Preventing misuse with ECRS that can be used with and without shield

IWG on CRS in Brussels 14 Januari 2016

- Insert a new par. 4.7. that will read:
4.7. Marking for Integral ECRS with shield system that can also be used without shield as non-integral ECRS

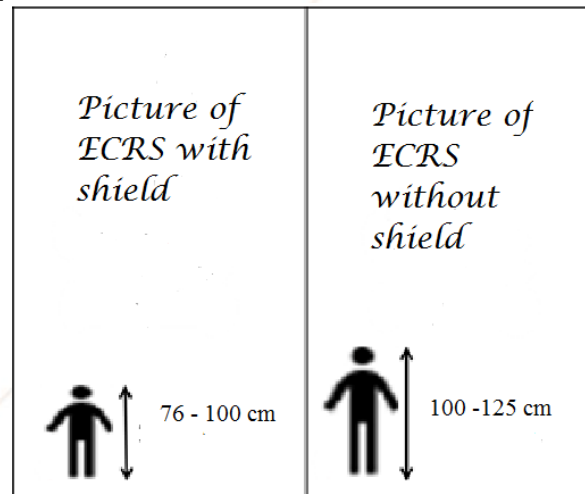
Needed changes in regulation to prevent misuse

These ECRS shall have a permanently attached label. This label shall be located on the outer surface, visible for somebody buckling up a child in this ECRS from the right or left hand side.
